AGENDA
Planning and Zoning Commission
January 18, 2023 – REGULAR MEETING

ITEM P22-253: Development Plan for a new 3-story mixed use building at the properties addressed 245 and 265 N. Millward St. Continued to January 18, 2023 Planning Commission Meeting.

Meeting Date:	January 18, 2023	Meeting Title:	Planning Commission
Submitting Department:	Planning	Presenter:	Tyler Valentine
Agenda Item:	P22-269 & 278: Request for a Land Development Regulation (LDR) Text Amendment to Section 2.2.9 and fee waiver.	Public Comment:	Yes

Meeting Date:	January 18, 2023	Meeting Title:	Planning Commission
Submitting Department:	Planning Department	Presenter:	Tyler Valentine
Agenda Item:	P22-242 Development Plan for a future 2-lot subdivision of the property located at 180 Aspen Drive	Public Comment:	Yes

A1.01

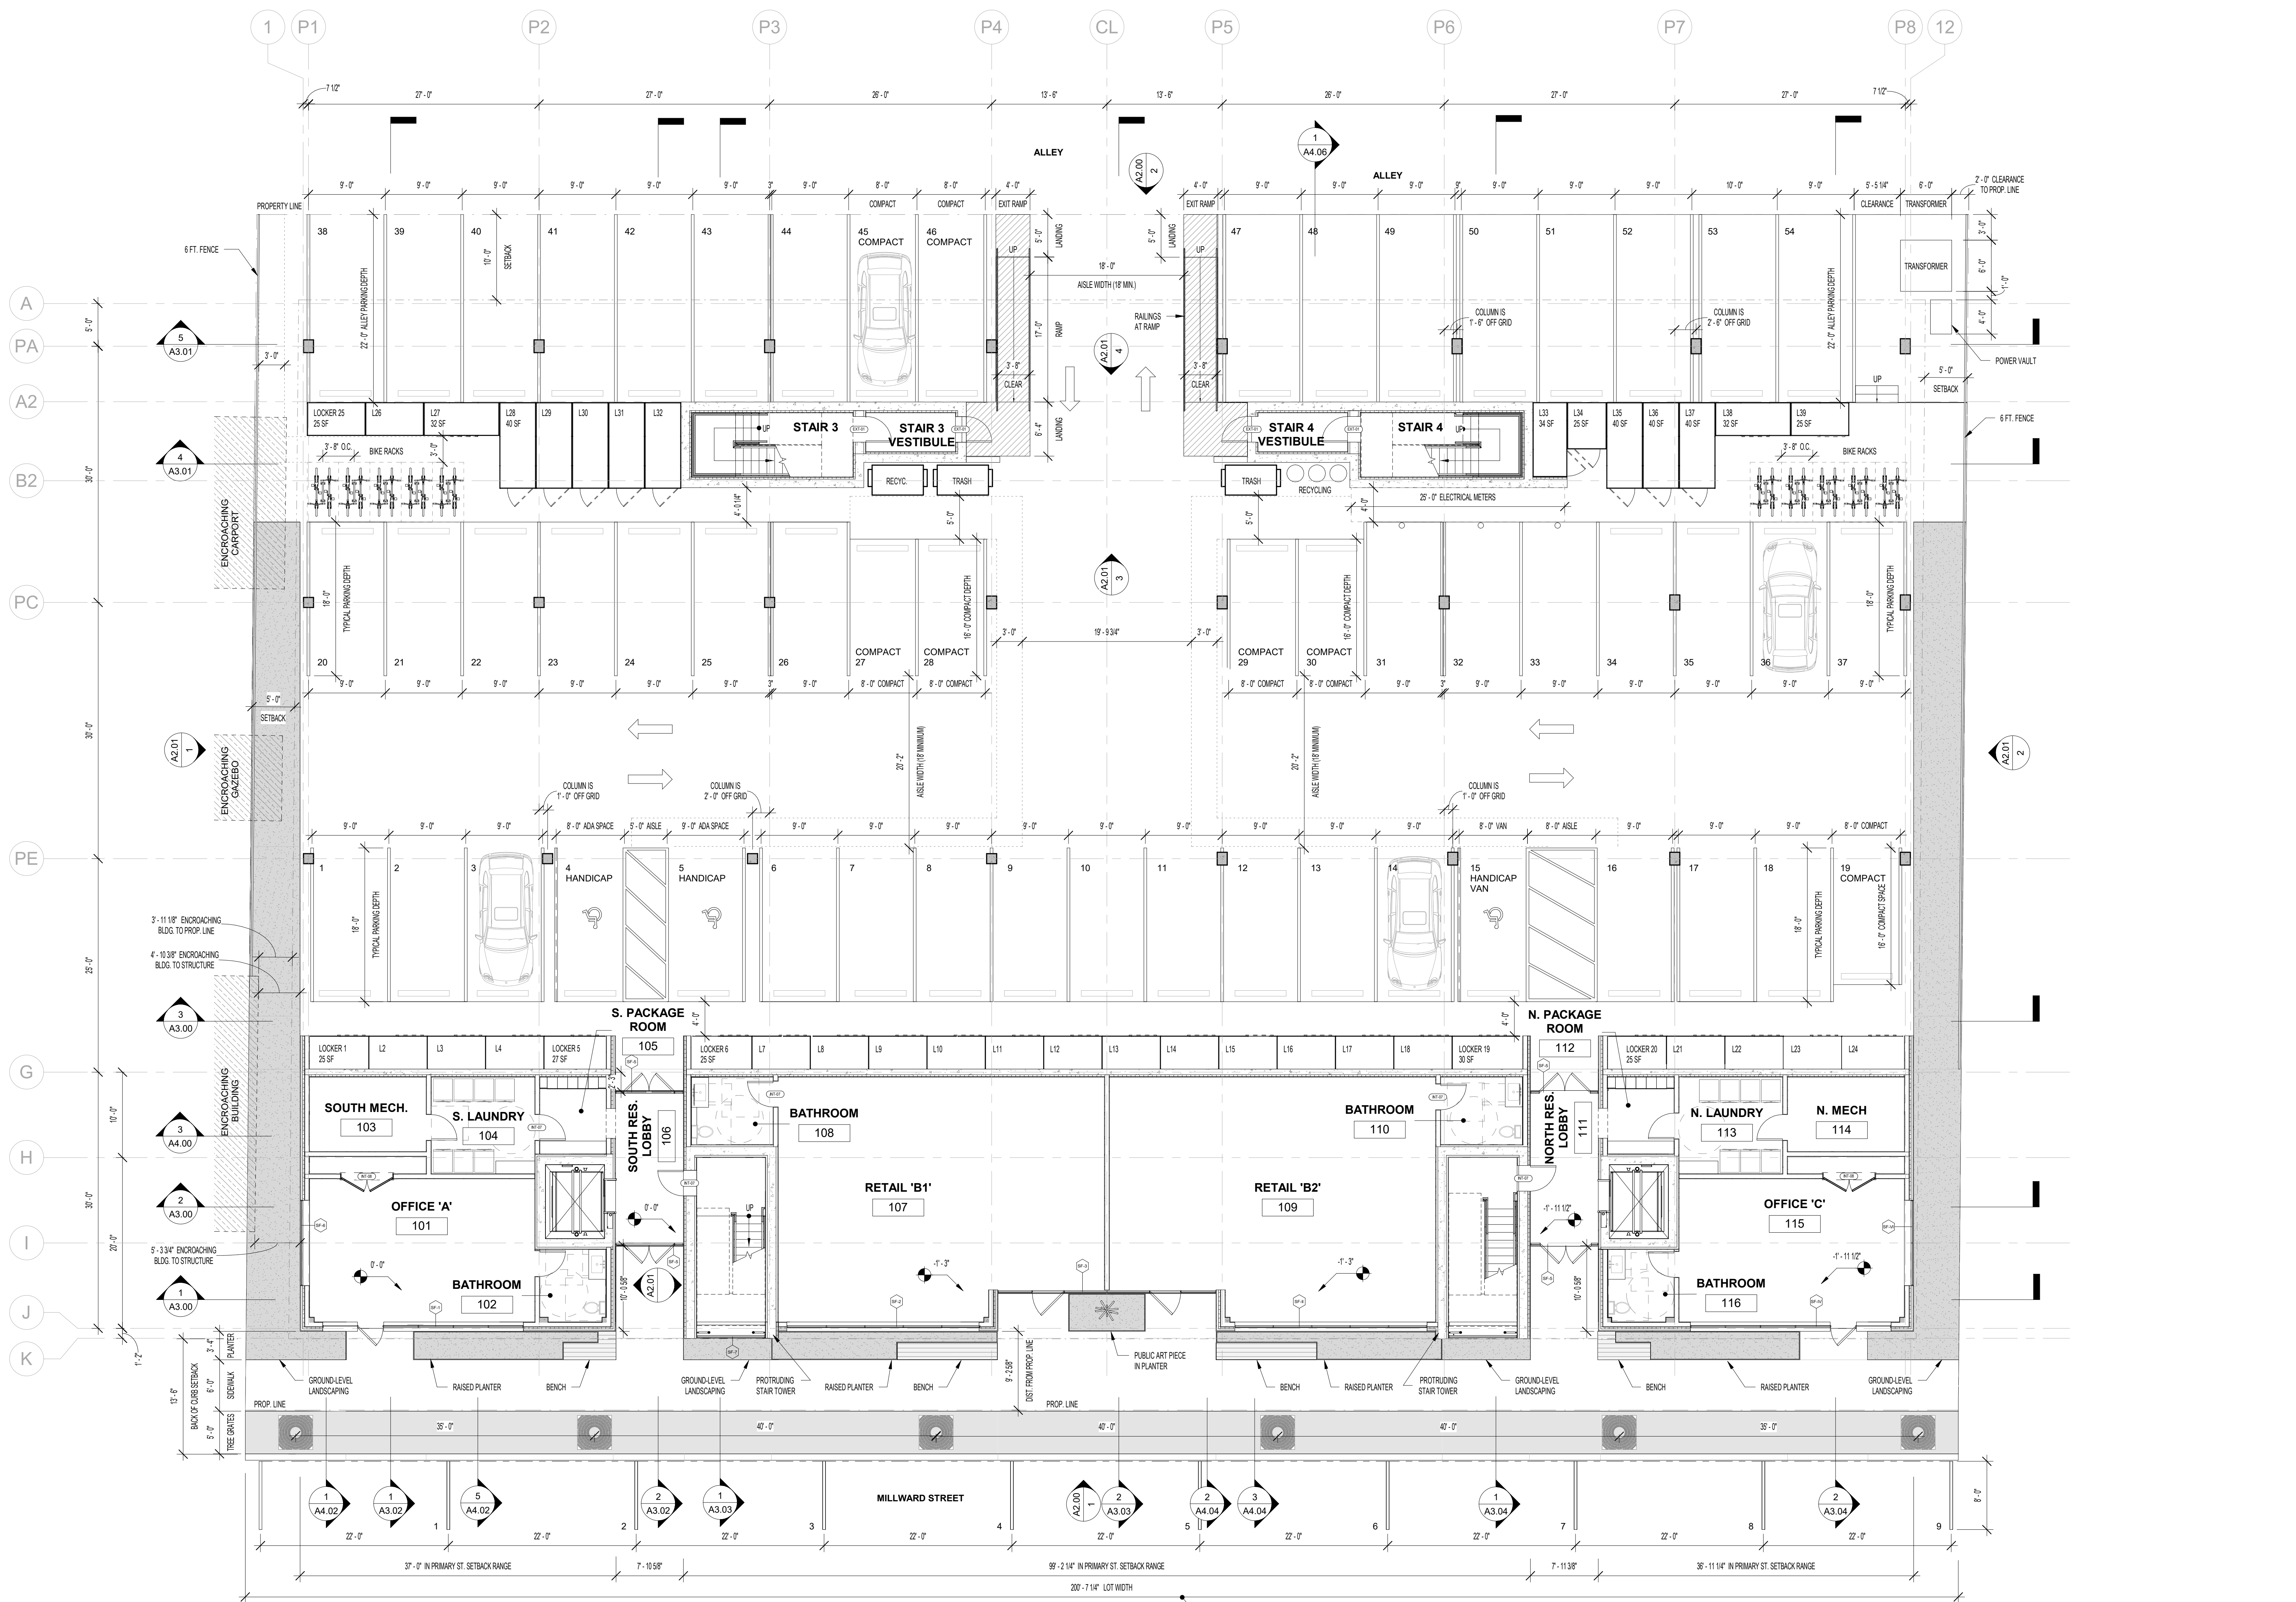
- Trash & recycling enclosure required. Revise plans to show location of trash enclosure or call out location if currently present. **Updated on A1.01, which shows two new walls to the west of the trash area (parallel to the alley) that will screen the trash and recycling from view. We believe that adding additional screening walls and/or doors/gates to access the trash enclosure will make it exceedingly difficult to roll away the dumpsters out for trash pickup. We have designed an ADA accessible path for approaching the dumpsters and believe that adding gates to screen them at the front will make it more difficult for a disabled person to take out the trash.**

- Revise plans to show dimension for distance between eastern property line and building. **Updated on A1.01.**
- Revise plans to show distance between existing “encroaching building” to the south and the proposed structure on 245 / 265 N. Millward. **Updated on A1.01.**

- Revise plans to show dimensions of on street parking spaces. **Updated on A1.01.**
- Revise plans to show dimensions of shorter compact parking spaces. **Updated on A1.01.**

- Please verify consistent dimensions for parking spaces in parking facility. It appears dimensions vary across different plans. **Updated on A1.01.**
- Revise ADA van space to be 8' wide with min 8' adjacent aisle. (11' + 5' shown). **Updated on A1.01.**

- Maximum of 8 compact parking spaces are allowed for parking plan with total of 54 onsite spaces. 9 are shown. **On A1.01, the column grids and parking layout were updated so that we now only have 7 compact spaces.**

- Revise plans to include 2' wheel stops at minimum for any parking space where vehicle overhang would impede amenities like walkways, storage locker doors, or bike rack (etc.). Planning Dept. suggests adding 2' wheel stops for all parking spaces. **Updated on A1.01.**
